Submission to

Casey Fields South Employment & Devon Meadows PSP, DSS & Amendment C295case

10, 24 & 70 Clyde – Five Ways Road and 45 Manks Road, Clyde

Issued
31 March 2025

Figure 1: Extract from PSP Plan 2: Place Based Plan (VPA 2025)

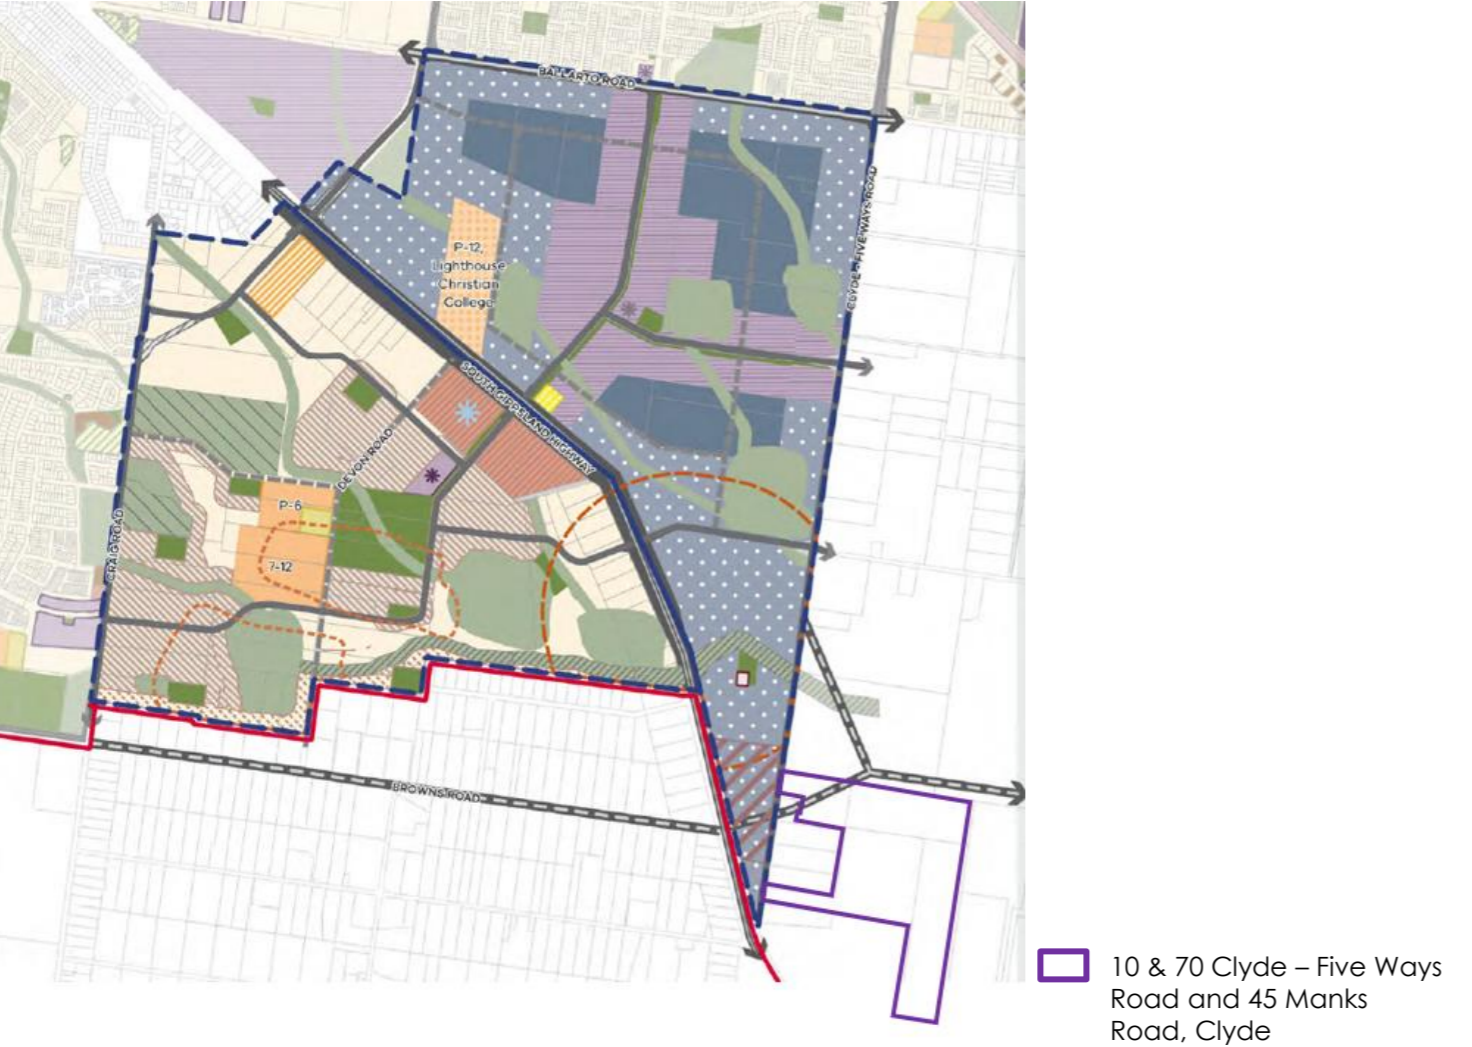
The CFS&DM PSP also illustrates an inductive future road network across the subject land despite the land not forming part of the CFS&DM PSP.

Based on a review of the CFS&DM PSP, DSS and Amendment documentation, our Pask **strongly objects to the draft CFS&DM PSP and the CFS&DM DSS as it applies to Clyde South and the subject land.**

Figure 9: Proposed PAO4 (Source: Exhibited Amendment C295case)

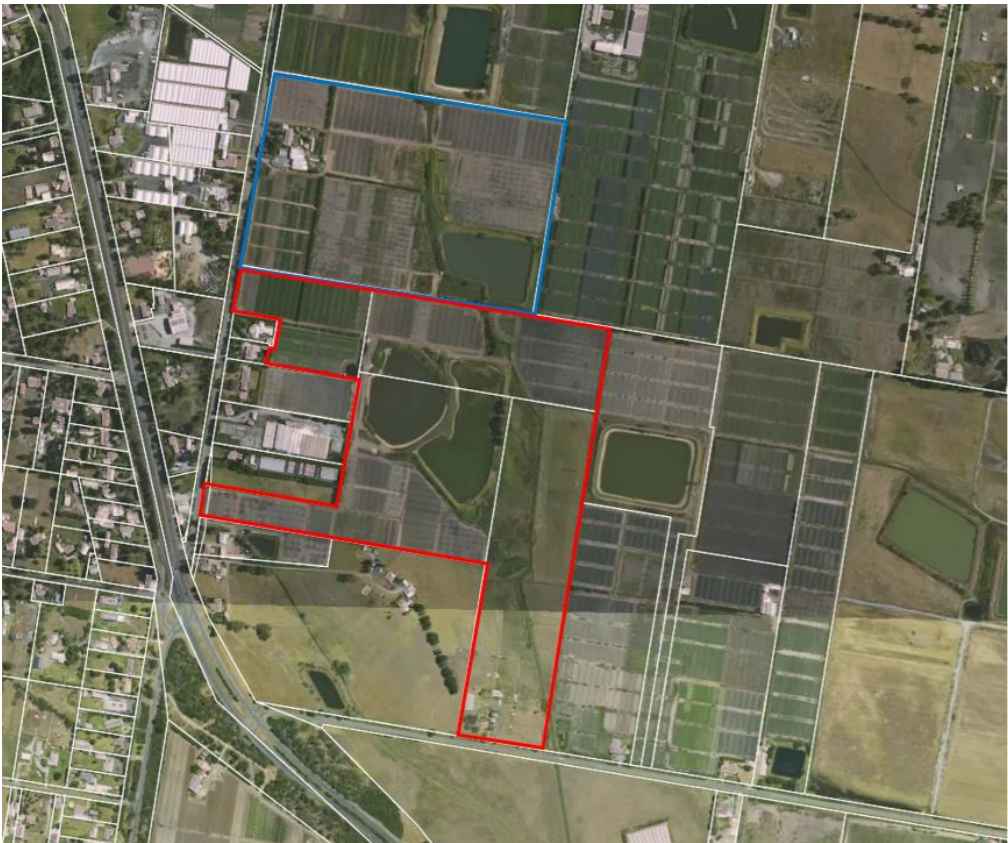
The CFS&DM PSP and DSS propose a 40m wide Public Acquisition Overlay over 90 Clyde – Five Ways Road which sits to the immediate north of the subject land. The CFSPSP and DSS notes that the PAO4 is required to facilitate the development of the precincts and to improve what Melbourne Water has described as 'legacy issues' associated with the Devon Meadows rural residencies located beyond the Urban Growth Boundary.

As a property located immediately downstream of the diversion waterway, it is submitted that our client's land will be significantly impacted. Notably, the Preliminary Drainage Investigations undertaken by Beveridge Williams indicate that the proposed drainage solution could increase flows passing through Clyde Five Ways Rd into the Clyde South PSP area by up to 100%.

To date, there has been no analysis to manage increased flows through Clyde South. Accordingly, **Pask strongly objects to the application of PAO-4 and the diversion waterway across the neighbouring site at 90 Clyde – Five Ways Road**

Figure 10: Preliminary Concept Drainage Strategy Plan (Source: Draft CFS&DM DSS - GHD 2024)

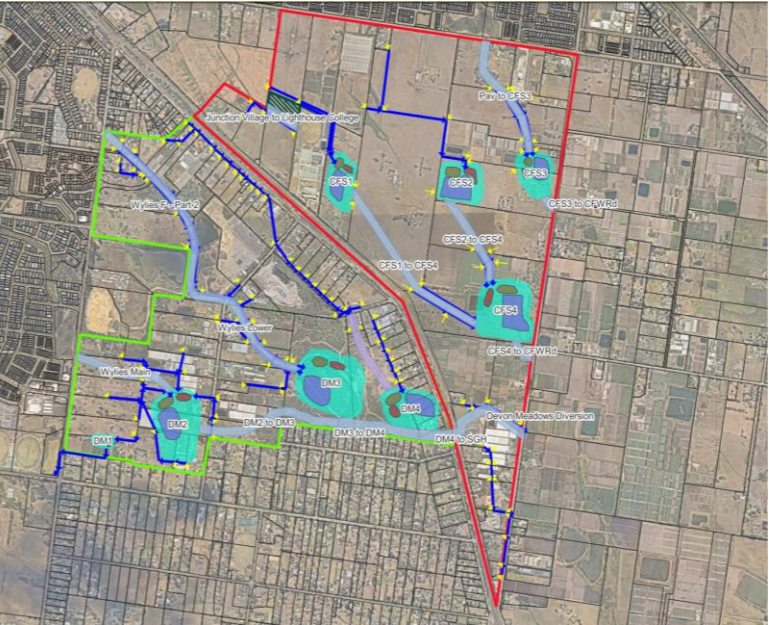
The stated purpose of this channel was to protect downstream homes in Devon Meadows from flooding and excessive increases in volumetric discharge. While redirecting flows from Devon Meadows would protect these homes from the issues above, its not clear how it solves the issue. Rather it just relocates it as a problem for the landowners on Clyde South to manage until such time as they PSP/DSS can be developed and implemented. Even then, the issue will require additional assets or negotiation with downstream owners to resolve.

- Preliminary analysis indicates that the diversion channel requires significant cut to achieve the required levels, particularly between basins DM2 and DM3.

- **At its deepest, up to 10m of cut will be required** which with the proposed 1:5 batters could require a reserve width of up to 100m at its widest rather than the 40m proposed by the PAO. This would require a significant volume of earthworks to achieve which will incur significant cost.

- When compared with GHD's groundwater observations, **it appears that significant sections of the channel are proposed to be below the groundwater level** which raises several key issues:

In summary, **the proposed channel appears to be a drastic and expensive measure directed at solving a problem that was not properly assessed/quantified.** It does not appear even resolve the perceived issue, instead just relocating it to a different location. It is strongly recommended that the diversion channel as proposed is abandoned and focus is placed on an alternate solution to protect homes in Devon Meadows.

At this time, the proposed strategy relies on 3 connection points (shown in images below). These points are characterised by:

- Roads being only marginally above the surrounding floodplain.
- An absence of any major drainage features, which are at best a small drainage channel and culvert and at worst no drainage feature at all.

- Removal of the diversion drain to be replaced with minor improvements to the existing channels downstream and including of a 225mm diversion drain for re-use.
- Redesign of the Devon Meadows basins to demonstrate that objectives can be met without the need to divert to Clyde South.
- Concept design of works downstream of Clyde Five Ways Rd to allow MW and the VPA to arrange a PAO to secure outfalls for Casey Fields.
- Additional concept design of a potential diversion drain around Lighthouse College.
- An examination of Casey Fields basins to determine if there is a more efficient/equitable distribution of assets.

Figure 10: Proposed transport network for Clyde South PSP (Source: Strategic Traffic Modelling Report Figure 4-2 (Jacobs, October 2024)

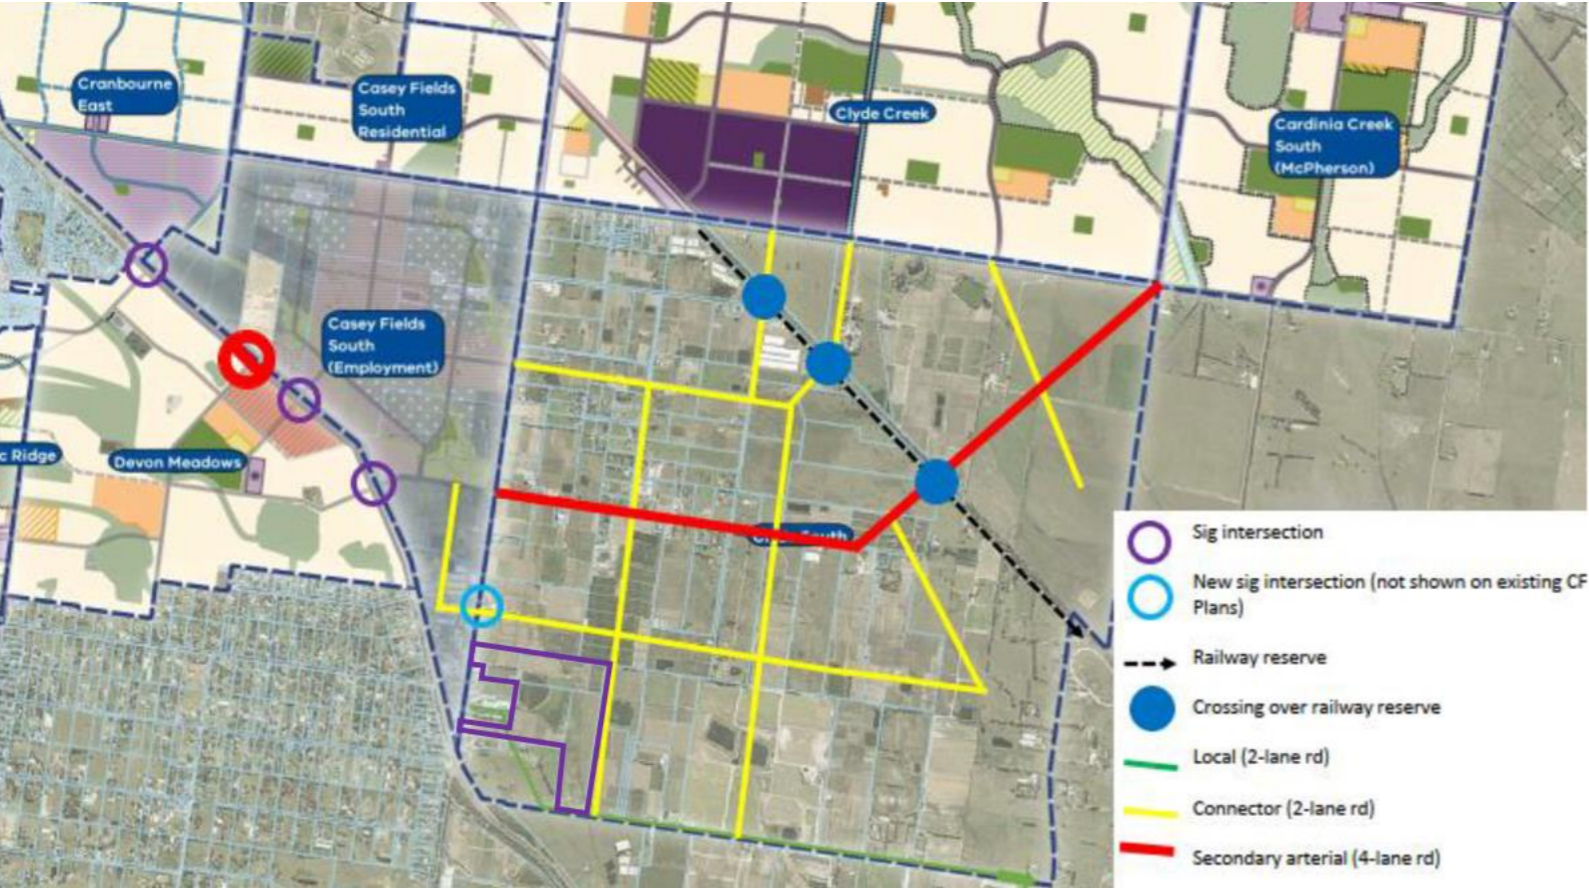
A review of the Strategic Traffic Modelling Report (which incorporates Clyde South) has been prepared to inform the proposed future road network for the CFS&DM PSP. Notably, the report does not provide commentary or imagery to support the indicative secondary arterial road as proposed on the subject land, as illustrated Figure 10.

It is submitted that the nomination of a future road network within the Clyde South PSP is more appropriately addressed through the Clyde South PSP.

It is submitted that the proposed road network as it applies to 70 Clyde – Five Ways Road must be removed from all plans within the CFS&DM PSP as it is not justified.

Figure 11: Extract from PSP Plan 4: Movement Network (VPA 2025)

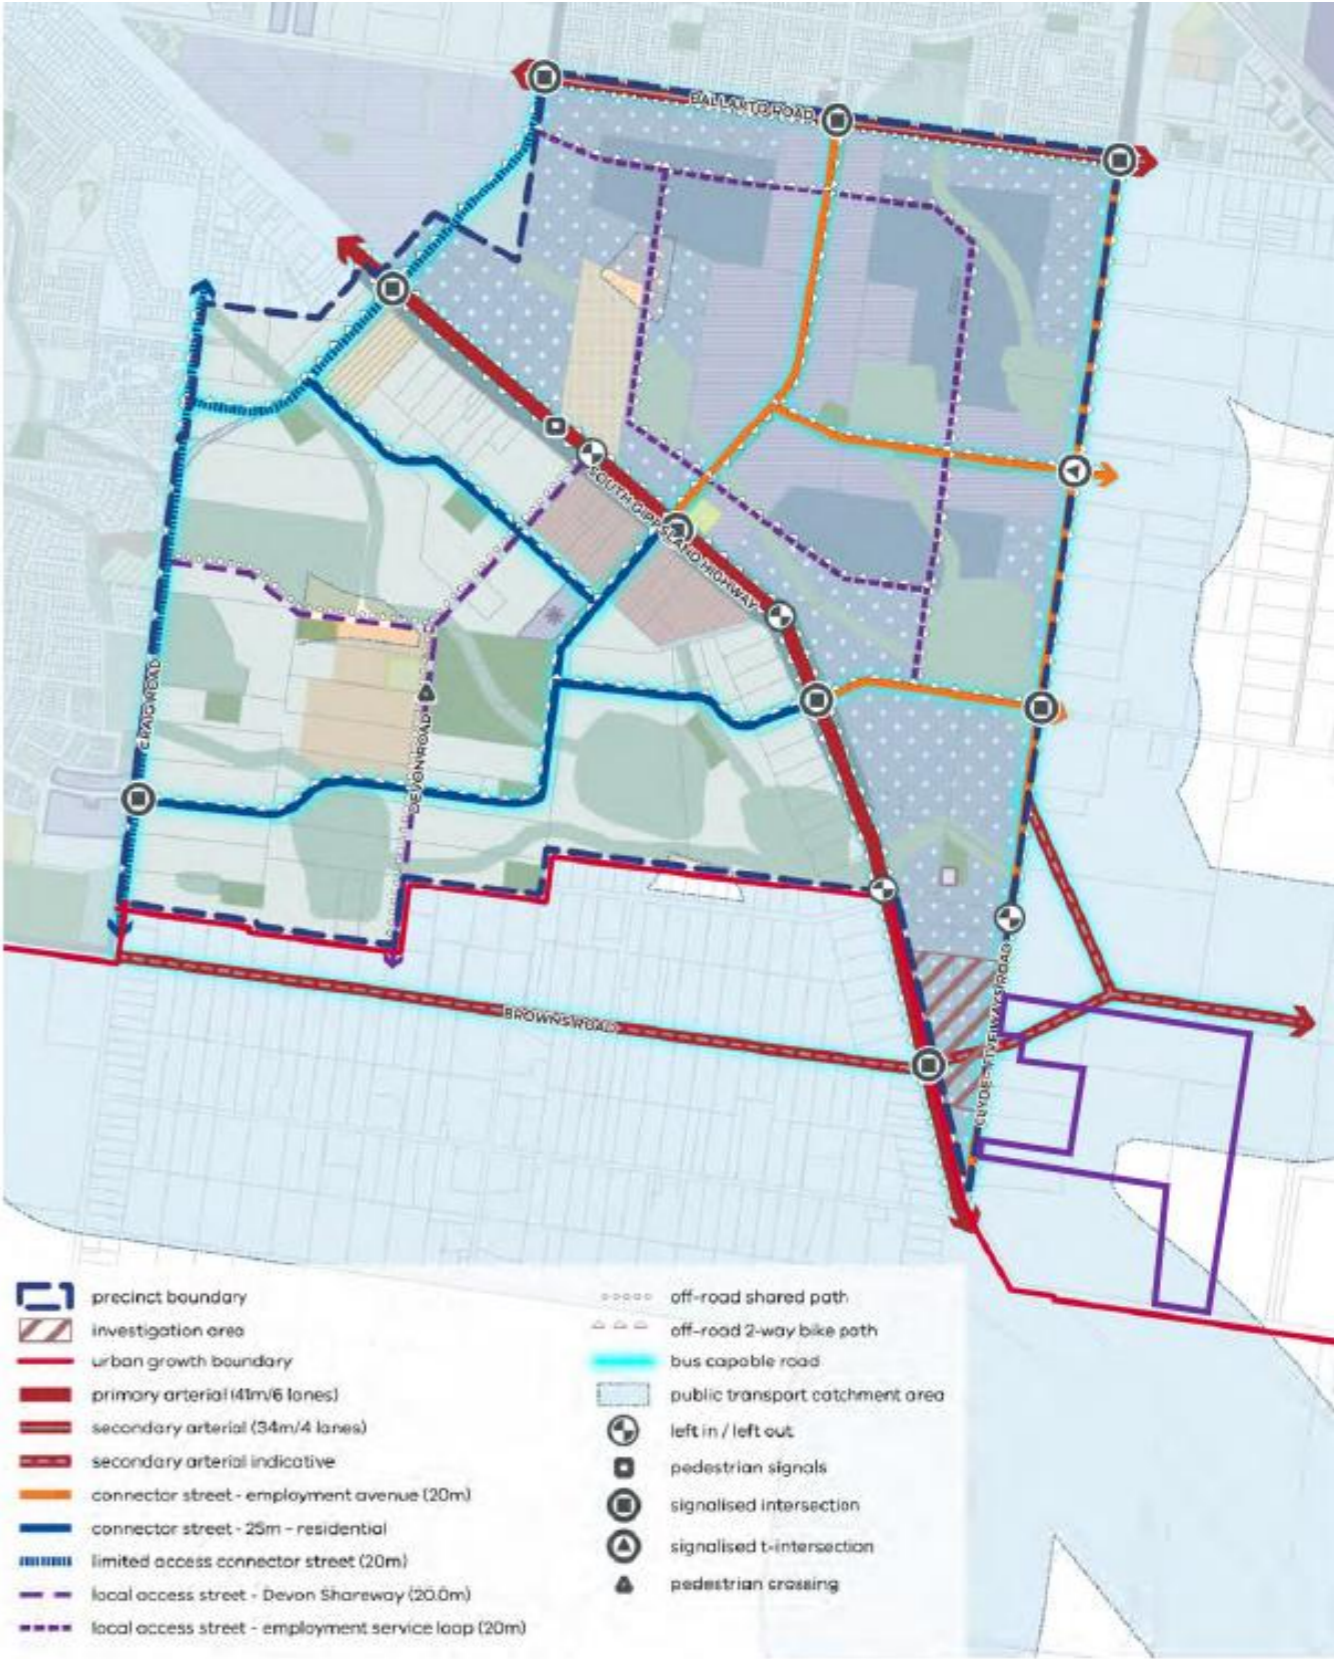
CFS&DM PSP Plan 4 – Movement Network identifies an indicative 4-lane secondary arterial road traversing 70 Clyde – Five Ways on a diagonal.
